Re: OEP/DPC/CB I
Freebird Gas Storage LLC
Docket Nos. CP05-29-000, *et al.*
§ 375.308(x)(3)

FREEBIRD GAS STORAGE, LLC
Docket Nos. CP05-29, *et al.*
Response to February 28, 2005 Data Request

Request No. 1

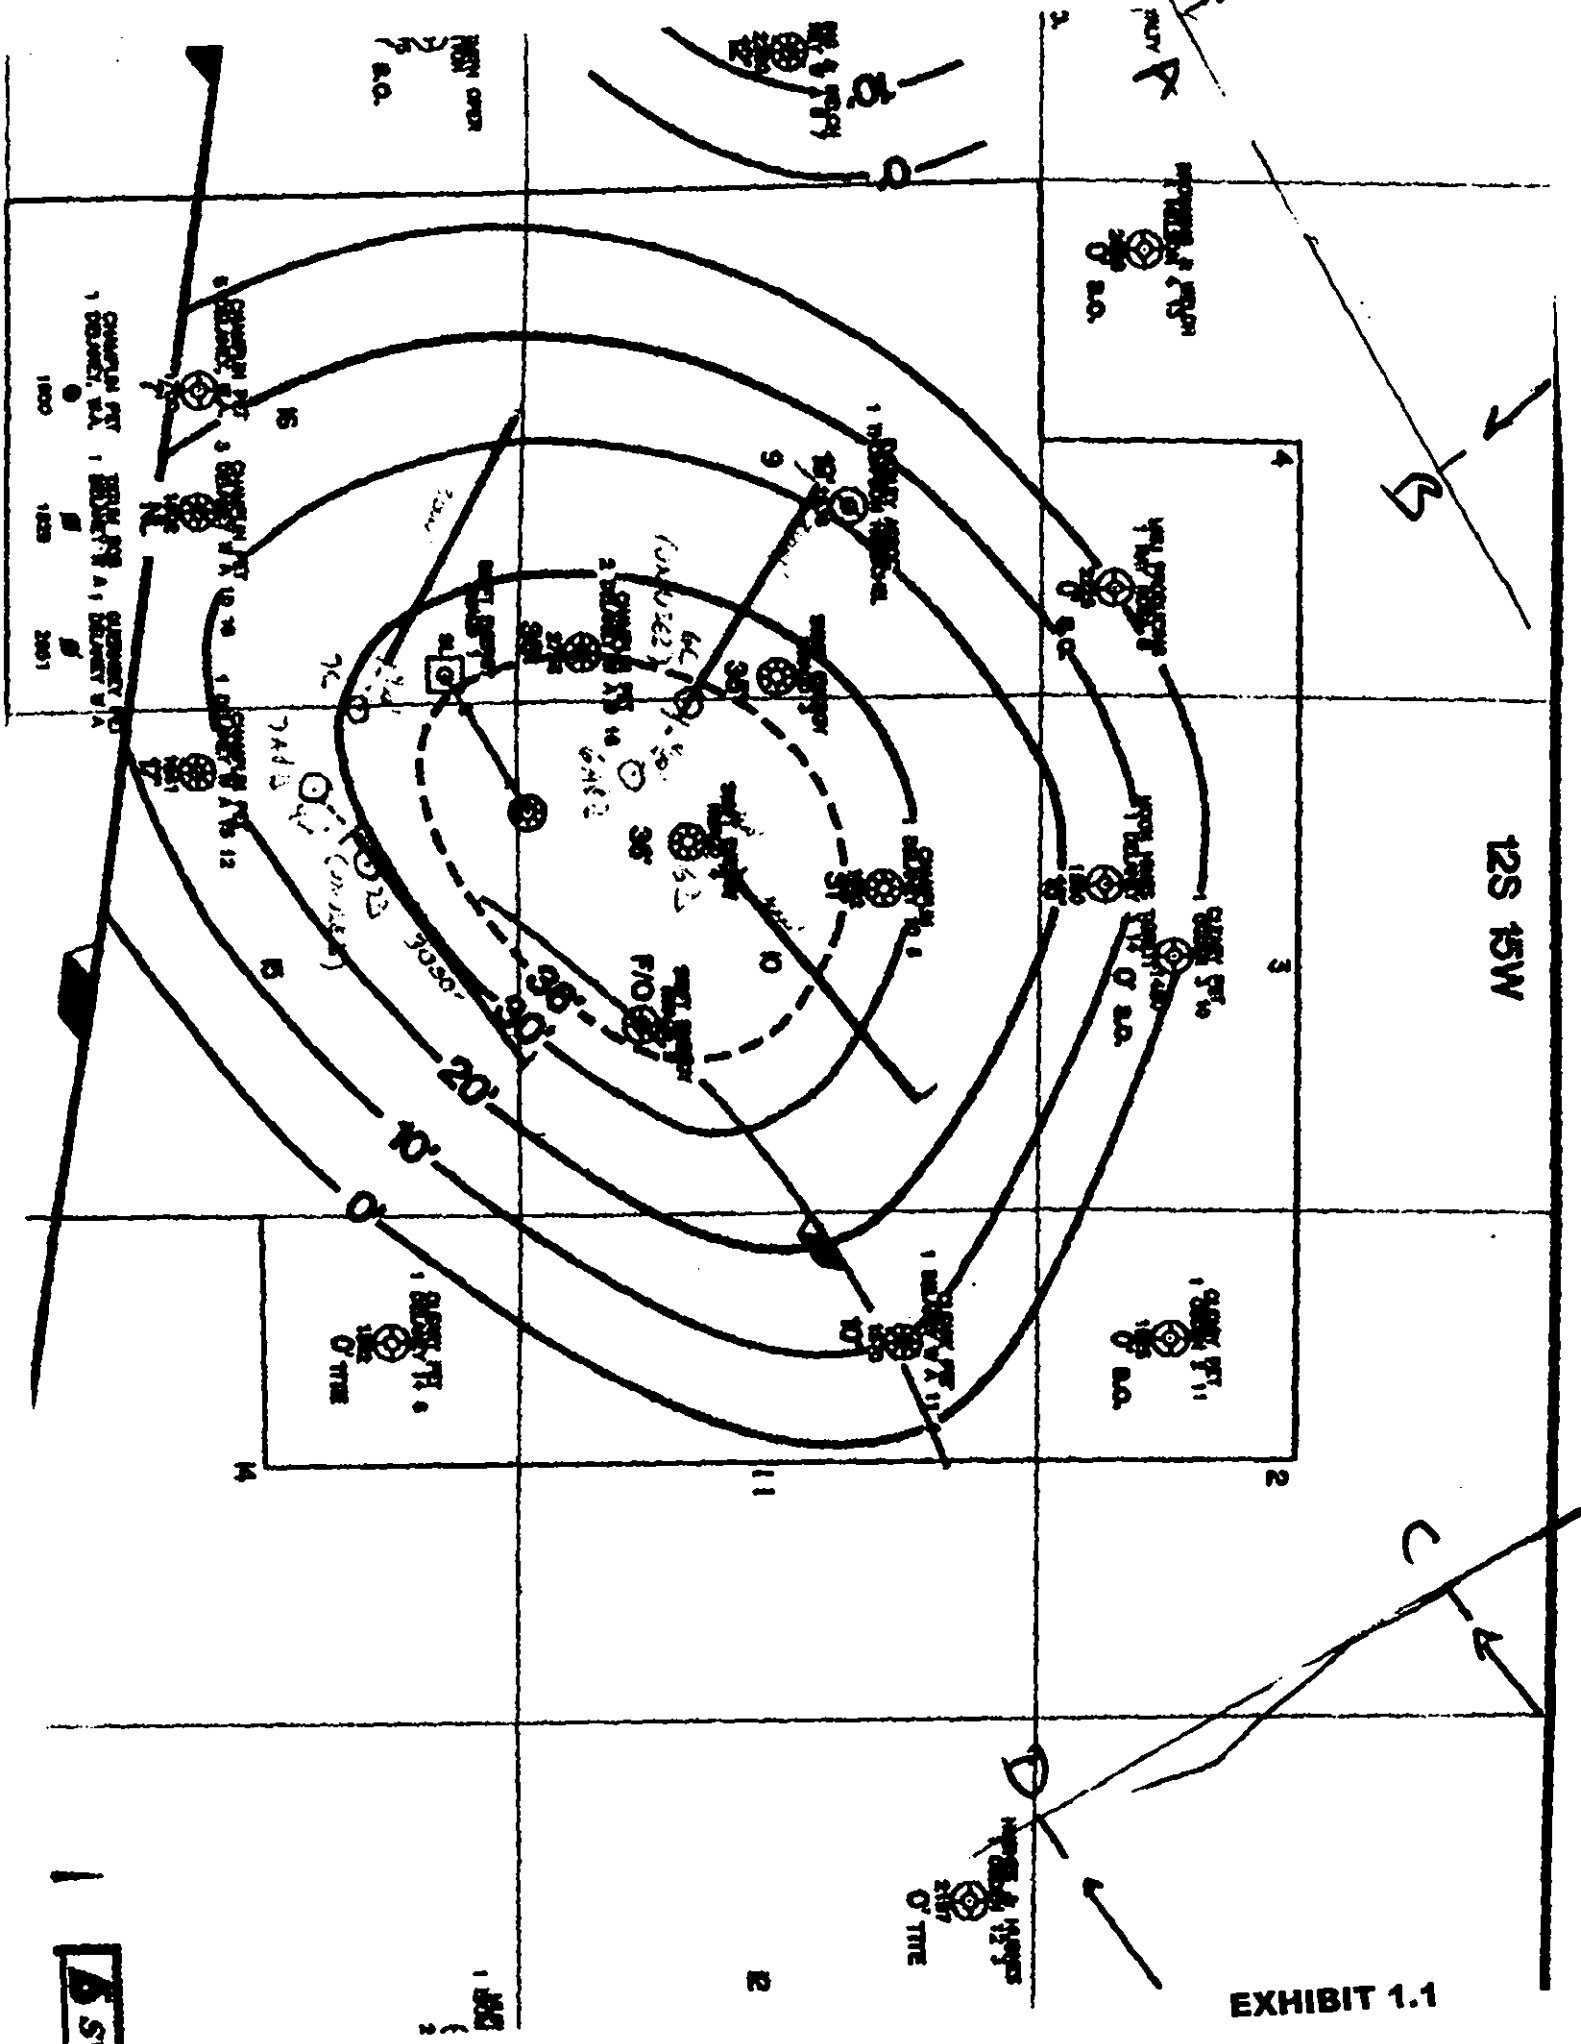
Please provide the latest isopach map of the East Detroit Storage Field, showing the storage reservoir boundary, as defined by fluid contacts or natural geological barriers; the protective buffer boundary; the surface and bottomhole locations of the existing and proposed wells.

The latest isopach map of the East Detroit Storage Field is attached as Exhibit 1.1. The reservoir boundaries of the Carter Sand are defined to the North, East and West by drilled wells in which the Carter Sand is either not present (shaded out) or in which porosity is absent (zero net pay). There is a sealing fault to the South that separates the field from established oil production.

The horizontal lateral extensions and final bottomhole locations for the four new wells contemplated for the Freebird project are superimposed on Exhibit 1.1. These locations are approximate; the final wellpath for each well will be determined by the results of the actual drilling and may vary slightly from the proposed locations, although none of the wellpaths will extend beyond the existing boundaries of the reservoir. Freebird may modify the drilling program as approved, monitored, and inspected by the State Oil & Gas Board of Alabama.

EDGS Inventory Performance

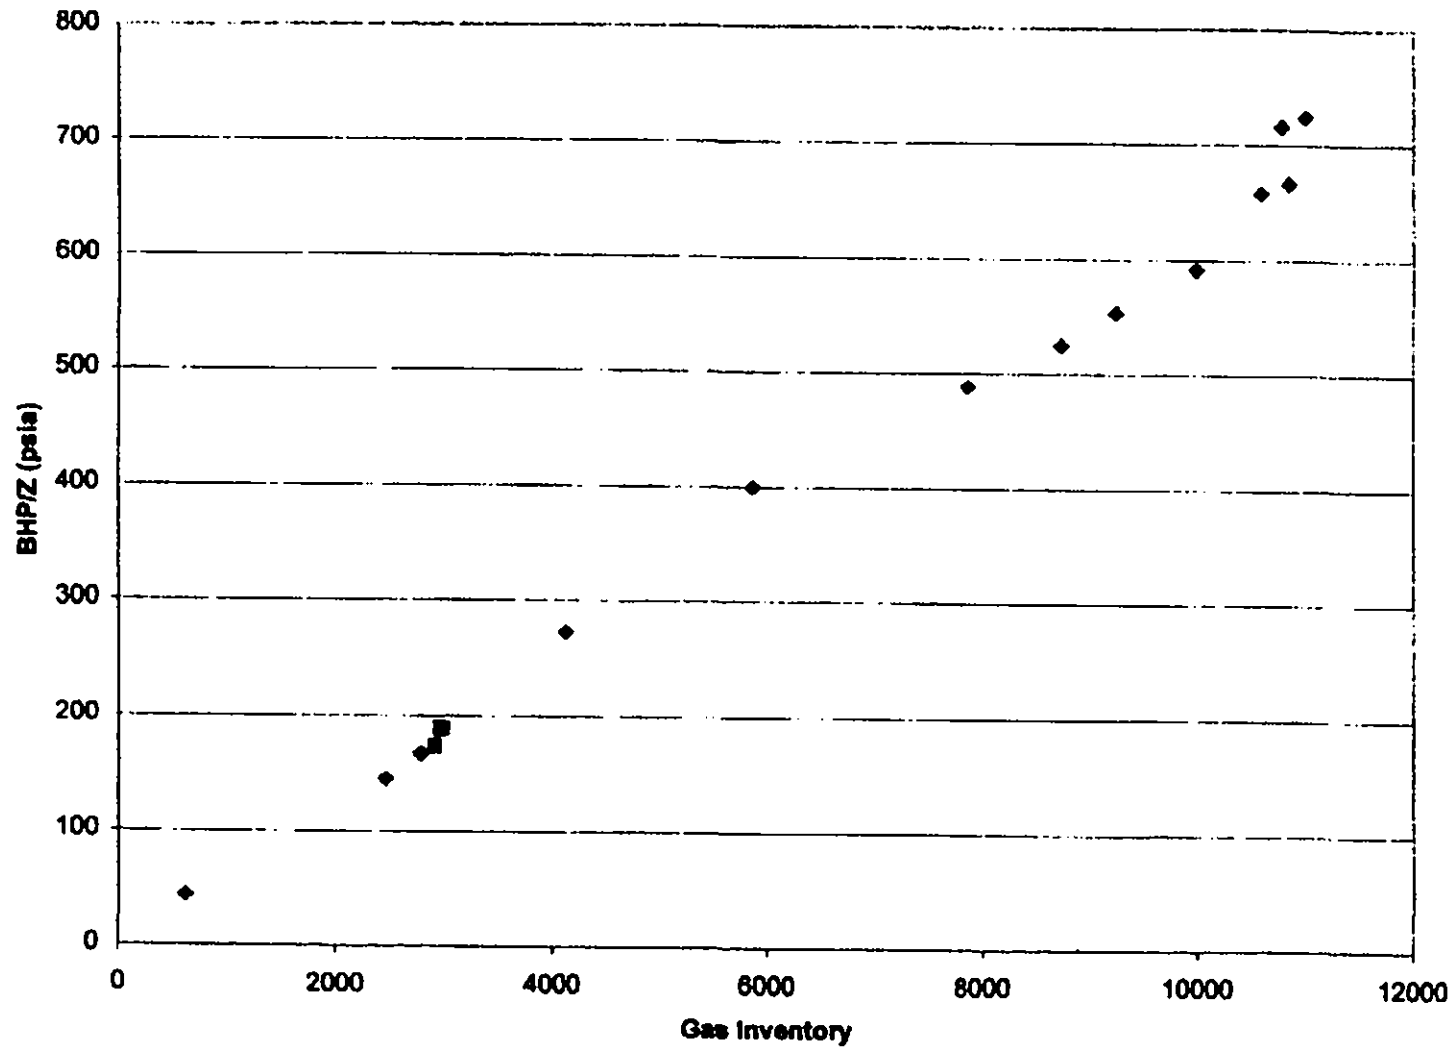
Please provide the latest inventory verification study for the East Detroit Storage Field, including all methodology, data, and work papers.

Please provide a detailed discussion of all existing or past operational problems for the storage field, including but not limited to gas migration and gas loss.

The latest inventory performance curves are attached as Exhibits 3.1 and 3.2, which indicate that there are no losses from the reservoir (to the extent that they can be identified by P/z performance).

There are no known existing or past operational problems with gas migration in the East Detroit Storage Field. Exhibit 3.2 represents a comparison of the original producing history of the East Detroit Gas Field and two repressuring cycles. Exhibit 3.2 suggests that there was no gas migration during repressuring and indicates performance typical of a closed reservoir, based on the P/z performance during primary depletion and subsequent repressuring.
